ADA Curb Ramp New Construction Inspection Form (Blended Transition)

NW. 314TH AVE

24953

NW. COMMERCIAL ST.

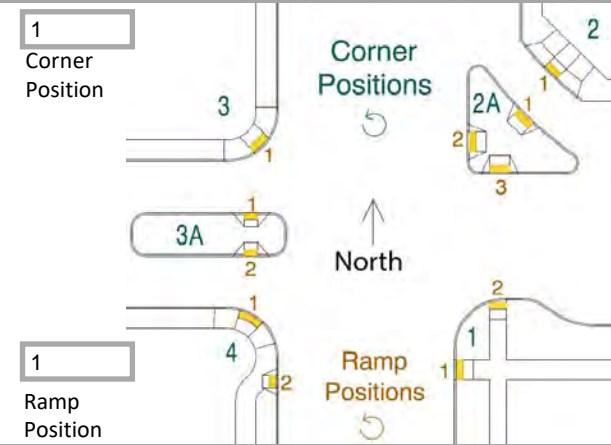
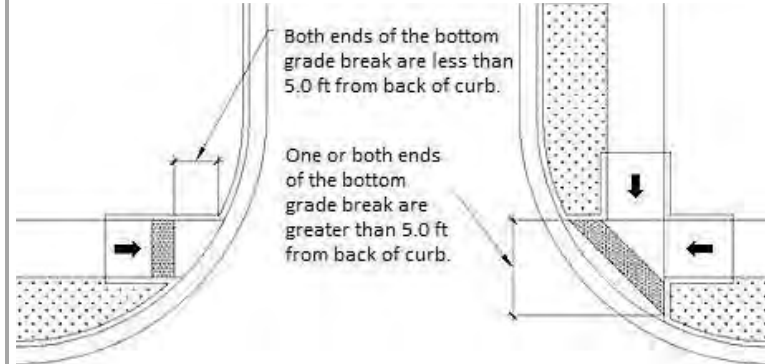
Comments:

No dome
